Item 4.**Development Application: 65 Martin Place, Sydney - D/2025/1160****File Number:** D/2025/1160**Summary****Date of Submission:** 20 November 2025, amended 6 and 17 February 2026**Applicant/Owner:** Reserve Bank of Australia**Architect:** Architectus**Planning Consultant:** DFP Planning Pty Limited**Heritage Consultant:** NBRS & Partners**DAP:** 2 December 2025**Cost of Works:** \$401,632,165.00

Proposal Summary: The application is for the full remediation and reconstruction of the heritage listed existing building, involving substantial demolition except for the existing basement, steel frame structure and southern boundary wall between levels 1-6, installation of new slabs and external facades, construction of a new building core and a replacement roof pavilion, and associated reinstatement of the Reserve Bank's original emblems, reconstruction of the Munro Garden and public domain works.

Figure 26: Extract of the LEP height of buildings map

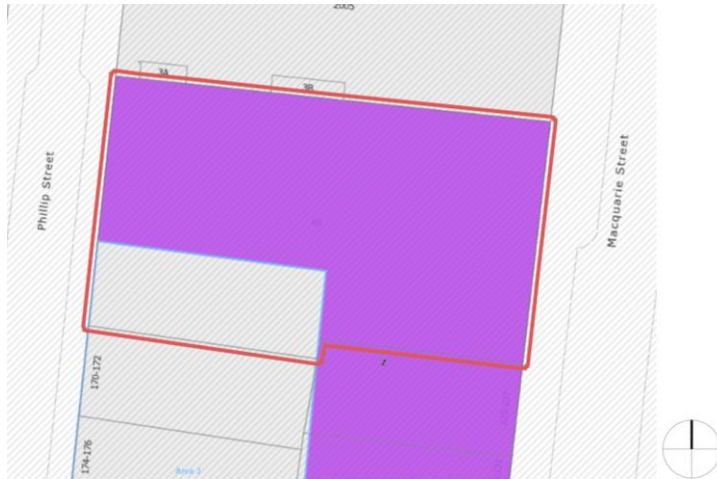
35. The site is subject to a maximum height of buildings control of 55m, except the south-western portion, where building height is restricted by the Hyde Park and The Domain sun access planes under Clause 6.17 of the LEP (Figure 26). The proposed development is compliant with the Hyde Park and The Domain sun access planes.

Figure 27: Elevation identifying the numerical development standard and locations of height exceedance

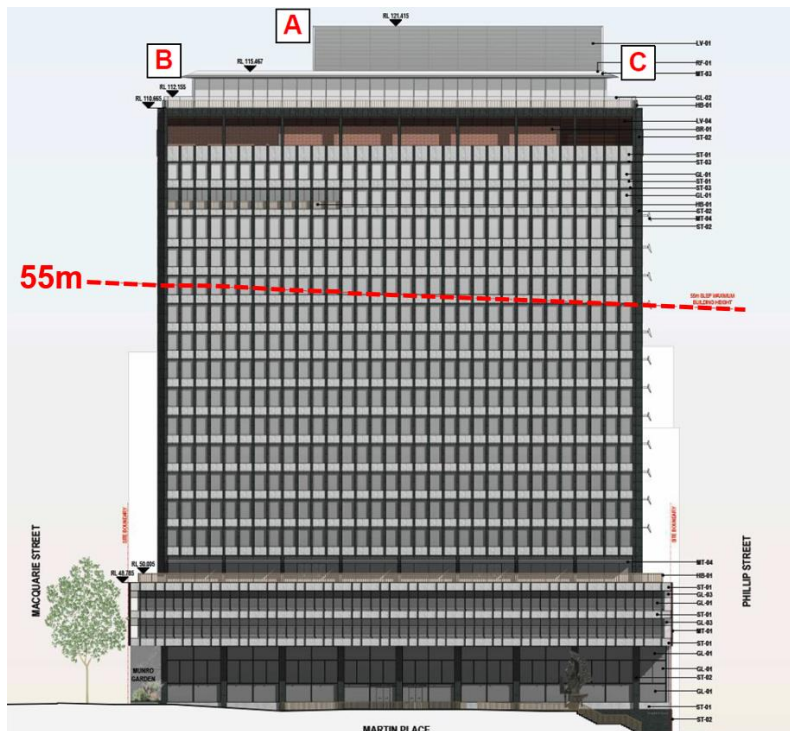
36. The existing building generally exceeds the numerical maximum heights of 55m. With the proposed development primarily reconstructing the existing tower, a variation to the numerical development standard is maintained, despite some minor reduction, while introducing new exceedance in the south-eastern portion of the site to accommodate the new building core. The proposed variations are as followings
- (a) Point A - new exceedance of 34.72m (63.1%) at the eastern side of the new building core;
 - (b) Point B - reduced exceedance of 28.08m (51.1%) at the eastern side of the roof pavilion; and
 - (c) Point C - reduced exceedance of 30.47m (55.4%) at the western side of the roof pavilion.
